UNITED STATES PATENT AND TRADEMARK OFFICE

Office Action Summary

10/799,220

- I. Claims 1-8, 18-20, 31, drawn to a polycentric prosthetic knee joint, classified in class 623, subclass 39.
- II. Claims 9-17 and 21-30, drawn to a rotary hydraulic chamber, classified in class 188, subclass 266.

Attachment

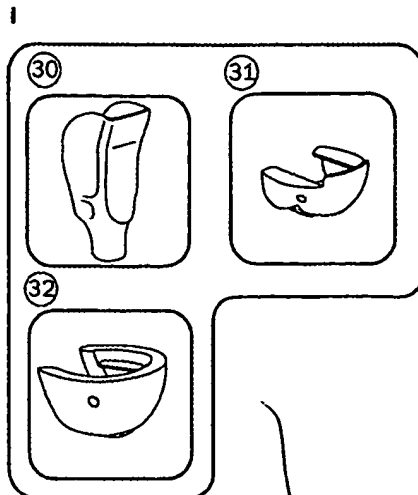
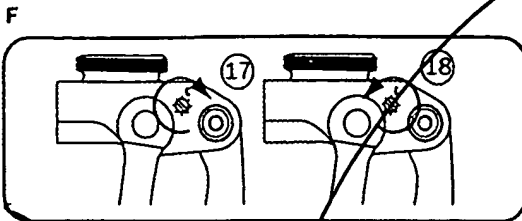
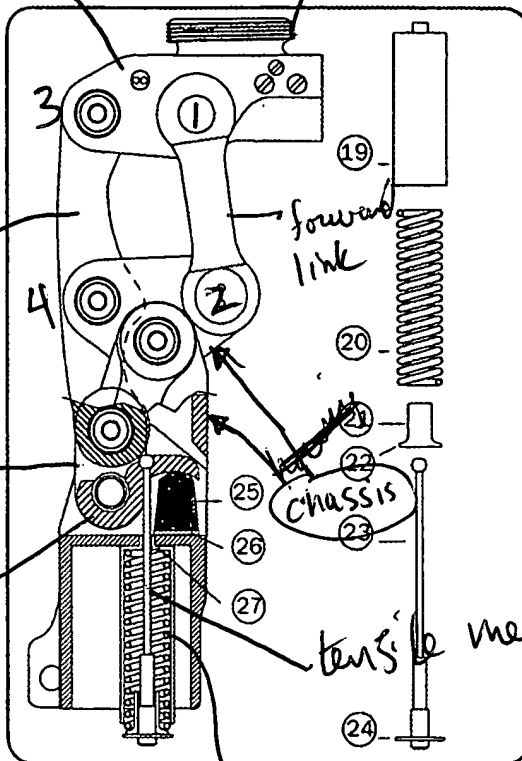
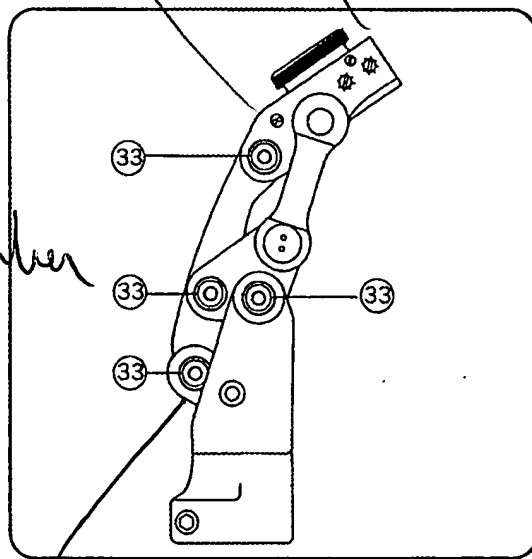
Claim 18 is rejected under 35 U.S.C. 102(b) as being anticipated by Total Knee 2000 Geometric Locking System Product Manual (applicant submitted).

The manual teaches the knee joint as claimed in claim 18; see attachment 1 for the Examiner's interpretation.
